Request:  
Compatibility Review  
of Canterbury  
Meadows, a 32-lot  
single family  
subdivision.

Applicant:  
Chris Brown, Prestige  
Builder Group

| Hudson Planning Commission | COMPATIBILITY REVIEW – CANTERBURY MEADOWS |
| Case No. 2025-1238         | Meeting Date: October 27, 2025            |

Figure 1

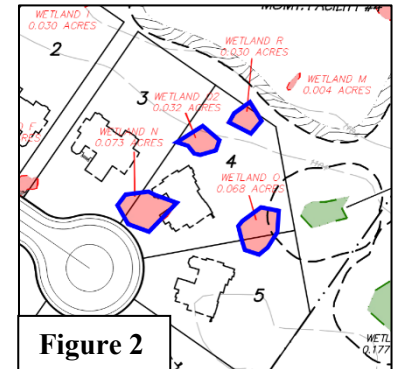
The applicant has submitted a map depicting the wetland and stream features that would be impacted by the proposed subdivision (See Figure 1). The map includes the following:

- Regrading the stream in the northwest portion of the property to construct a stormwater management pond
- Regrading the existing Pond #1 and .112 acres of wetlands to a stormwater management pond
- Impacts to approximately 0.2 acres of wetlands to establish sublots 3,4, and 5.
- Impacts to approximately .125 acres of wetlands to construct a stormwater management pond at the southeast portion of the site.

The proposal would require City of Hudson approval and Ohio EPA approval to disturb the wetlands and stream. Based on such, staff notes the following:

- Staff acknowledges the drainage way at the northwest corner of the site has been identified as a stream; however, incorporating the proposed stormwater improvements along the stream would provide appreciable stormwater benefit for the drainage area.
- Staff notes several small wetland pockets are located south of Ravenna Street. These wetland impacts could be reduced through one of the following approaches:
  - Reconfiguring sublots 3-5 and the trail entrance to preserve the wetlands highlighted in Figure 2 and incorporate into the open space block. It appears a mix of shifting ROW west, reducing lot depth, and/or clustering could be considered.
  - Consider onsite mitigation, which is the process of creating or enhancing wetlands on the same property to compensate for wetland impacts.

1. Wetlands: Reconfigure sublots 3-5 and the trail entrance to preserve the wetlands highlighted in Figure 2 and include in the open space block or implement onsite mitigation.
